Form 3160-5
(June 2019)

SUNDRY NOTICES AND REPORTS ON WELLS
**Do not use this form for proposals to drill or to re-enter an
abandoned well. Use Form 3160-3 (APD) for such proposals.**

8. Well Name and No. Drickey Queen Sand Unit #34

**Drickey Queen Sand Unit 34
30-005-01030
Acacia Operating Company, LLC
June 30, 2025
Conditions of Approval**

Acacia Operating Company, LLC		PROPOSED	
Author:	Abby @ JMR		
Well Name	Drickey Queen Sand Unit	Well No.	#34
Field/Pool	Caprock; Queen	API #:	30-005-01030
County	Hobbs	ocation:	Sec 10, T14S, R31E
State	NM		1980 FSL & 1980 FEL
Spud Date	5/15/1954	GL:	4278

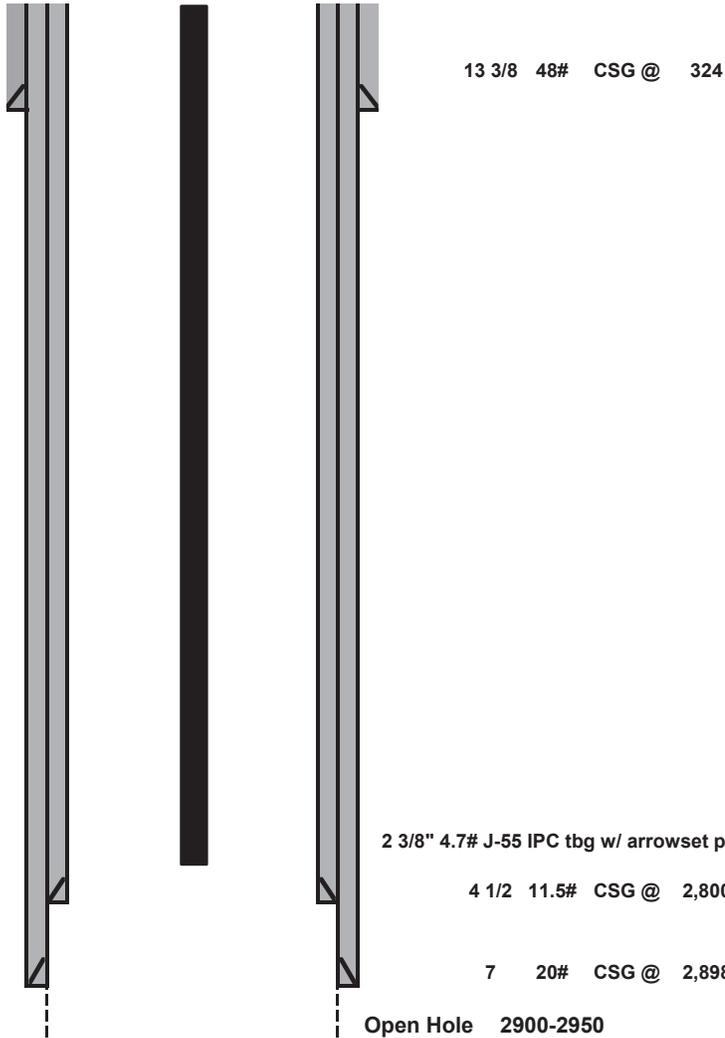
- 1. Operator shall place CICR at 2,750' and squeeze 42 sxs class C cement.**
- 2. Operator shall place a balanced Class C plug from 2,750' to 1,932' to seal the Yates and bottom of the Salt. WOC and TAG.**
- 3. Operator shall place a balanced Class C plug from 1,425' to 1,022' to seal the top of Salt and Rustler.**
- 4. Operator shall perf at 374' and squeeze cement class C cement to surface to seal the 13-3/8" casing shoe.**
- 5. Dry hole marker must be below ground.**
- 6. Surface reclamation will need to be completed once the well bore has been plugged. Please contact rflores@blm.gov for additional information.**
- 7. See Attached for general plugging stipulations.**
